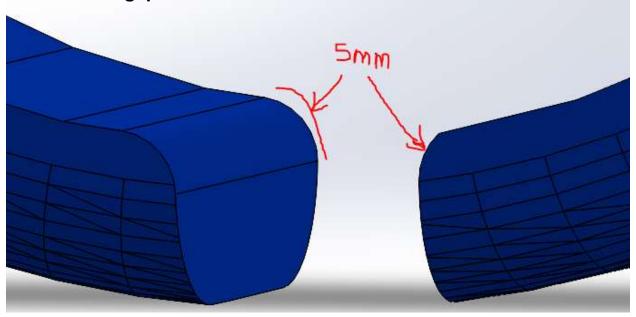
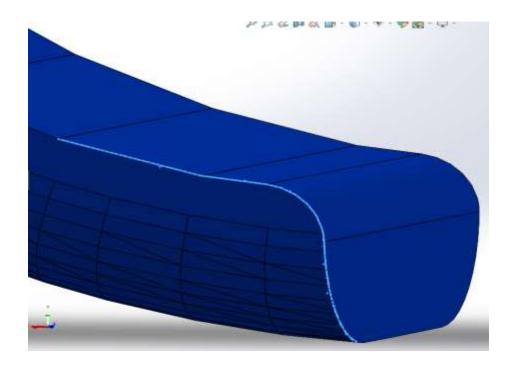
It has a 2mm gap. This is how it looks with the final modification

3D printing cannot do this rounding correctly because the filament is very thick, if I do it with 0.5mm it is a lot, it has to be 0.2mm or 0.1mm, honestly it is very little, the software can do it but the 3D filament cannot.

I suggest that at the end of the 3D print, you buy a nail file or #0 sandpaper for wood and file only the sharp parts.
